BAR Meeting
July 1, 2015

ISSUE: New Construction: Buildings 1 and 2

LOCATION: 2 Duke Street

BAR 2015-0189 & BAR 2015-0190

BLDG 01 - OVERALL ELEVATIONS

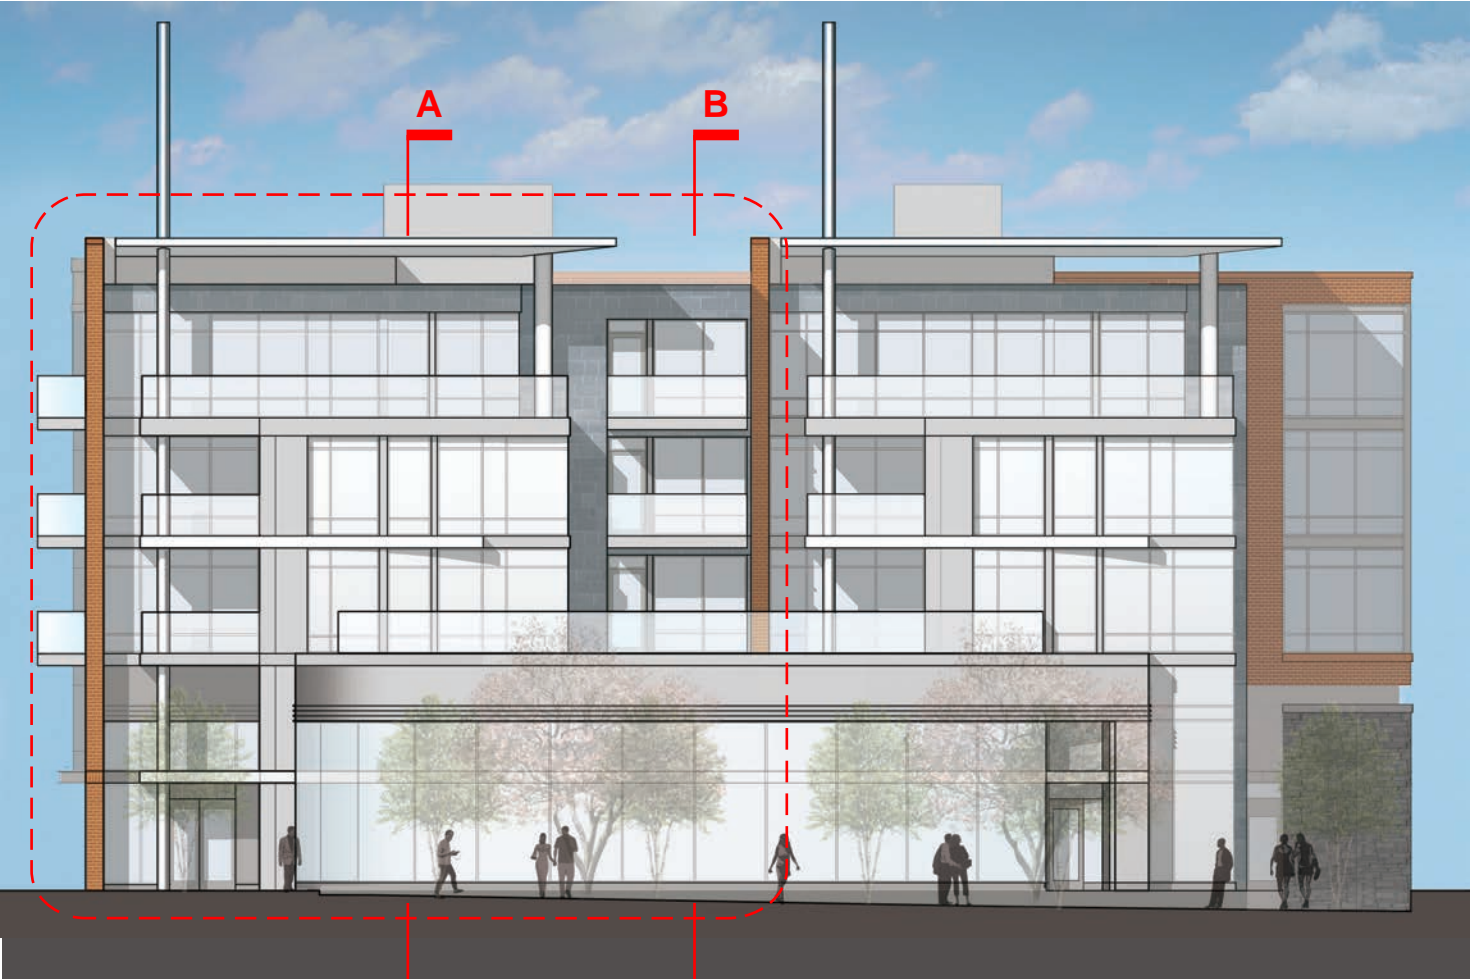
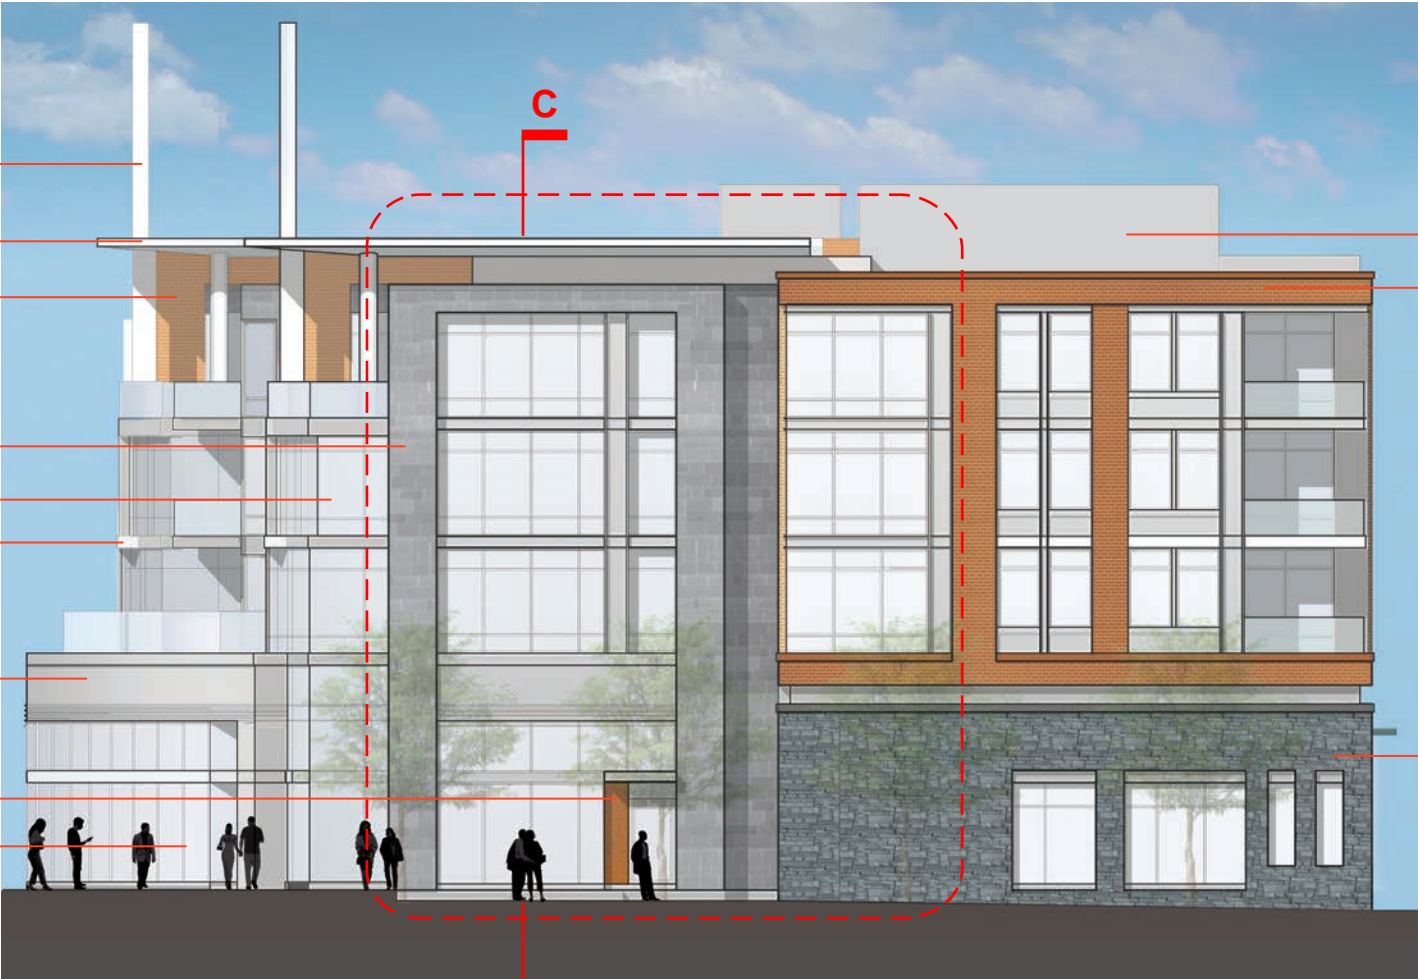
5. At Building 1:
 - a. The restaurant section at Building 1 should relate more to the building’s stylistic vocabulary and be integrated with the overall design composition, as well as create a strong presence on the north elevation reflecting this significant project cornerstone.

In addition, the BAR generally supported a curving glass form for the restaurant but wanted it to be more substantial, in order to be a signature feature and to read as a two-story space, reflective of the airy interior. The current design approach is capped by a heavy ribbed fascia band reminiscent of the Art Deco style that is somewhat foreign to the rectangular vocabulary of the rest of the building. Staff would prefer to see less of the ribbed metal banding and more glass, as the current proposal makes the restaurant's form seem like a disparate component that is not integrated with the overall design. Staff has no objection to the curved glass railing above the

fascia but finds that it will be better integrated if the area below has more glass and less metal panel. Such a change could also influence the east façade of the residential units above, further differentiating the waterfront elevations of Buildings 1 and 2.

WEST ELEVATION

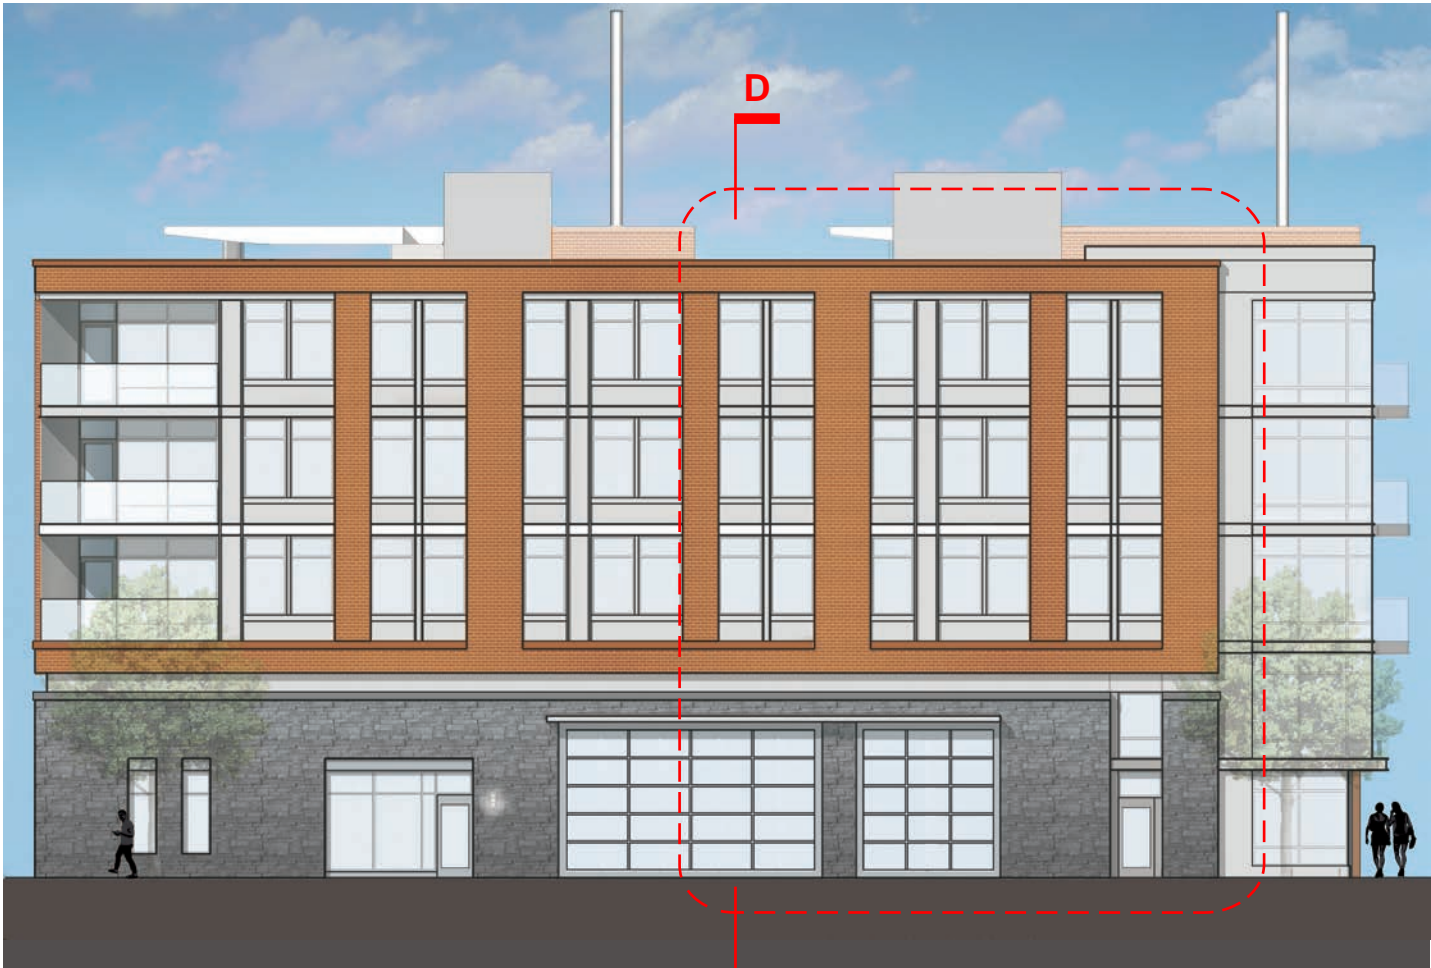
- c. Select a stone lighter in color and with a more random rustic rubble configuration, similar to that at Fitzgerald’s Warehouse.
 - d. Remove the awnings above the garage doors and recess the garage and loading doors.

Figure 2. West elevation of Building 1 showing stone base, garage/loading doors and applied brickwork.

Building 1 is a building without a “back” as the west elevation is on The Strand and will be a significant walking street despite the locating of the garage entry and loading dock on this elevation. Staff recommends a clean approach to this area and advises removal of the small canopies and the use of translucent doors within a more pronounced recess to reflect that these are large openings within a masonry wall.

BLDG 02 - ENLARGED SOUTH ELEVATION

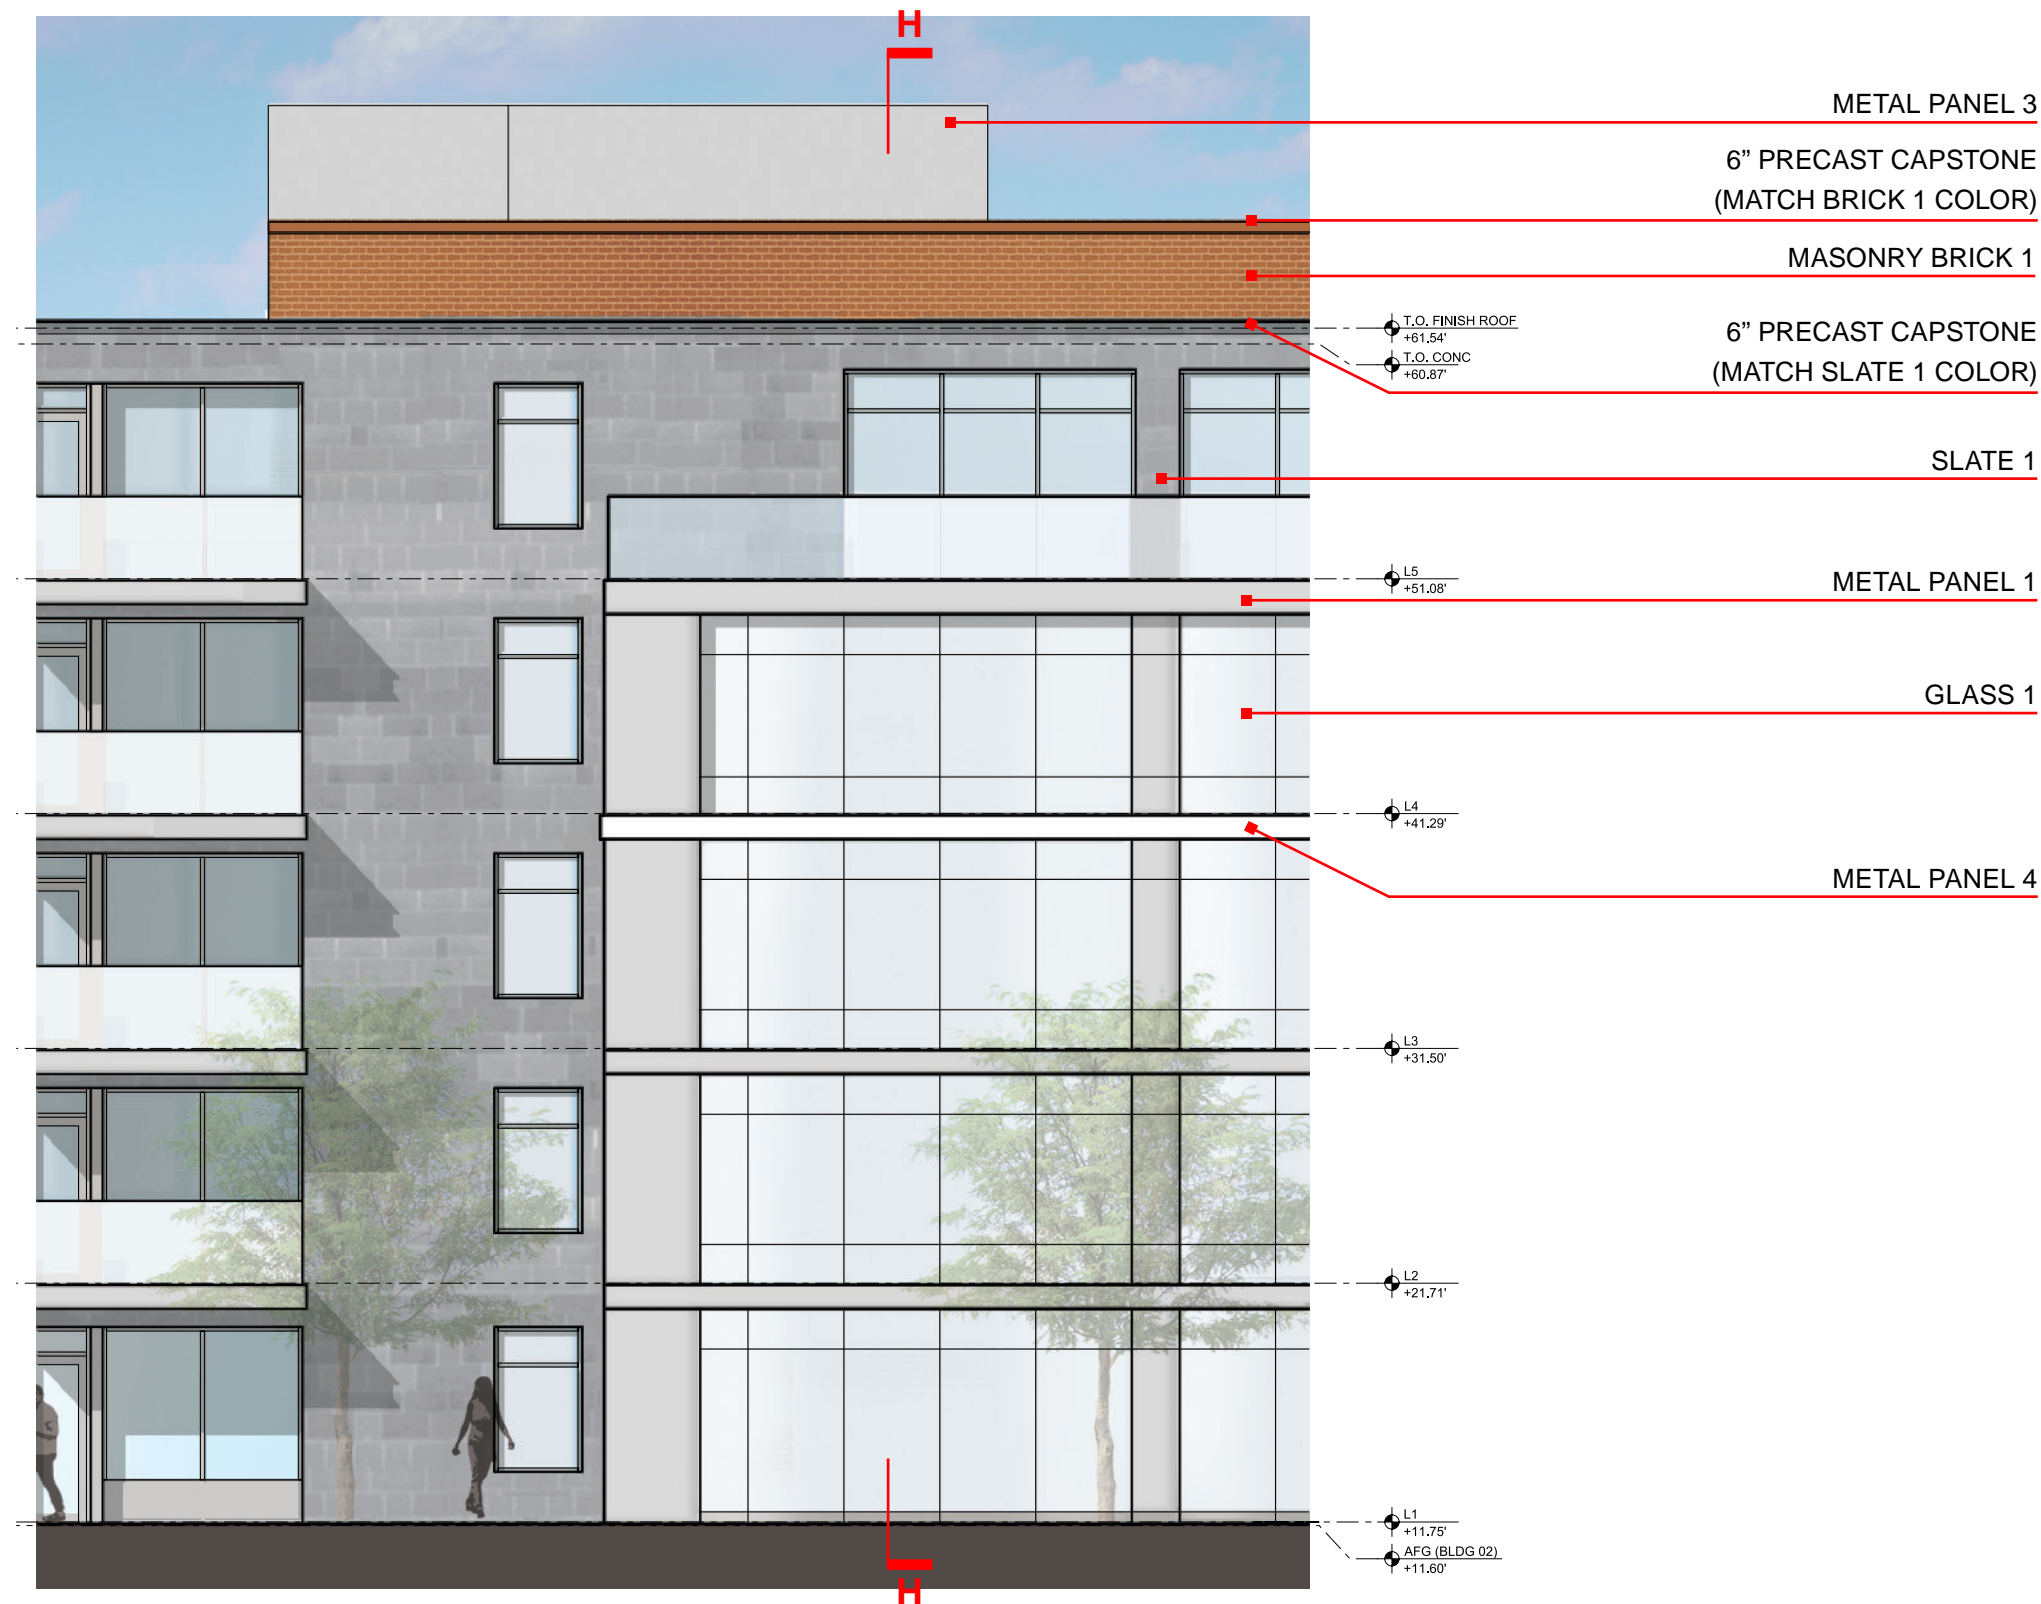
6. At Building 2:
 - a. Add brickwork and sunscreens to the south elevation to better relate to other elevations.
 - b. No residential doors are permitted at the first floor on the waterfront elevation.

In general, Building 2 is quite successful and the applicant should continue in this design direction. While the rear elevation, which features substantially more brick than the other three elevations, may appear repetitive, staff notes that it will only be visible in relatively small segments through the various alleys and paths and will have meaningful streetscape improvements including street trees. However, the south elevation of this building needs further refinement. Staff notes that it is the only elevation of the two waterfront buildings without any brick. While not the sole cause, the lack of brick here does contribute to a stark appearance to this elevation. Therefore, in keeping with the other patterns of how brick is used on these two buildings, staff recommends that the wall immediately to the east of the central balconies be brick. Additionally, to soften this elevation and relate the residential character of this part of the building, a solid sunshade should be considered at the fifth story that would wrap around slightly to the waterfront. The addition of this element would further distinguish Building 2 from Building 1 while adding an interesting architectural feature.
